Project Number: W-2021-0208B
PWSID#: 43603648
DNR Region: NER
County: Manitowoc

WATER MAIN PLAN AND SPECIFICATION APPROVAL

Project Description: Water main extension on River Point Drive, York Street, North 11th Street, and Buffalo Street. These extensions will include approximately 2,400 feet of 8-inch ductile iron pipe.

**MPU
IMPERVIOUS CLAY WATERMAIN TRENCH PLUG
DETAIL**

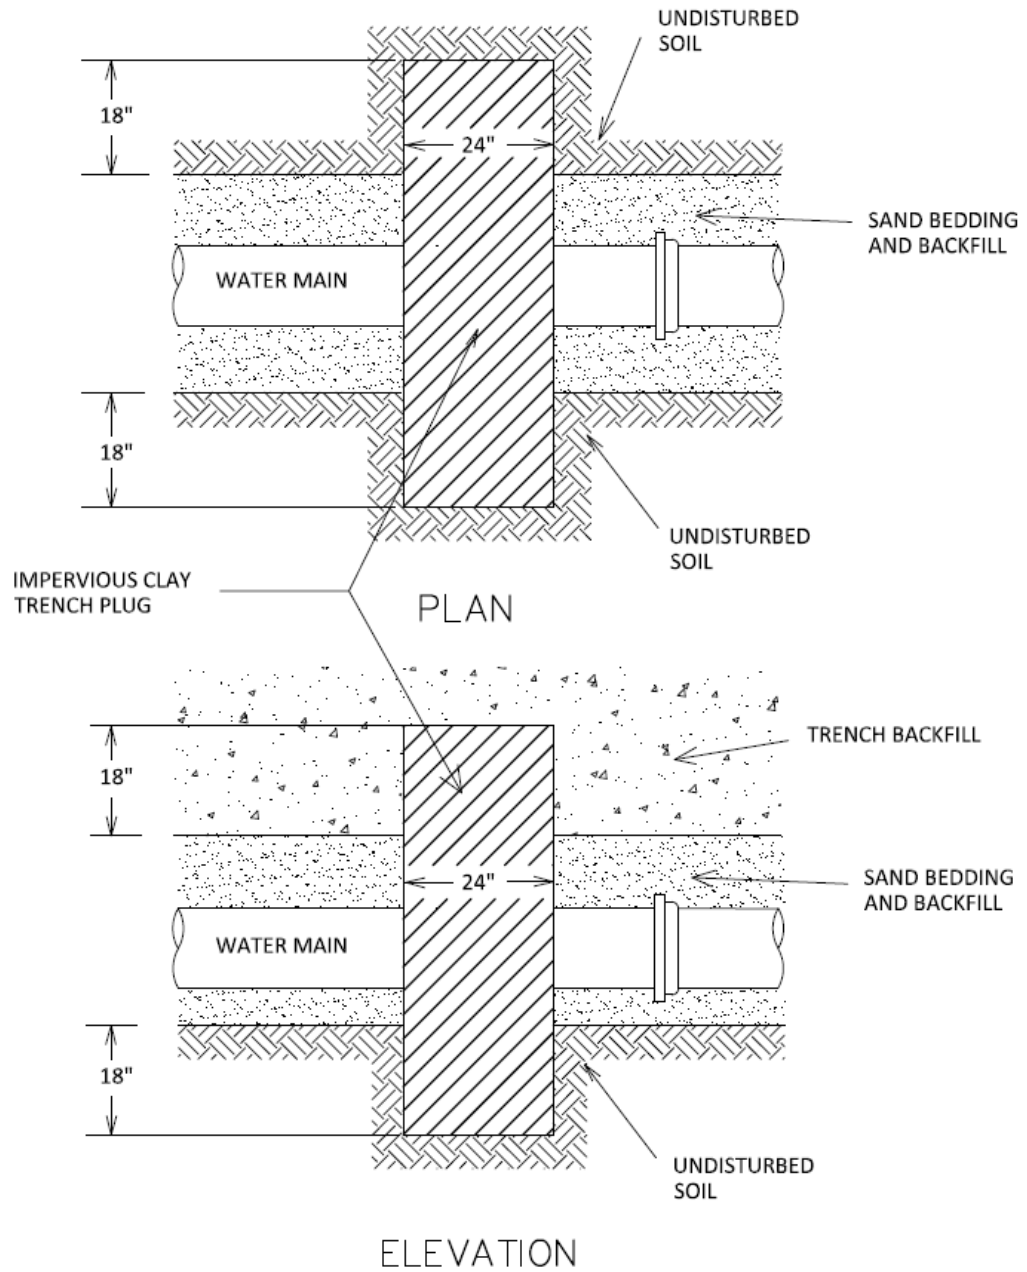
As part of the permitting process, Ben Mand (WDNR Public Water Plan Review Engineer - Drinking Water and Groundwater Program) asked that a clay wall (plug) be installed in the utility trench at the property boundary. Attached is MPU's detail for that plug that will be passed to the contractors.

1. IMPERVIOUS CLAY MATERIAL SHALL BE FREE OF ROCKS, STONES AND VEGETATION.
2. CLAY SHALL BE MOISTURE CONDITIONED AND MECHANICALLY COMPACTED TO THE SAME DENSITY AS ADJACENT BACKFILL.
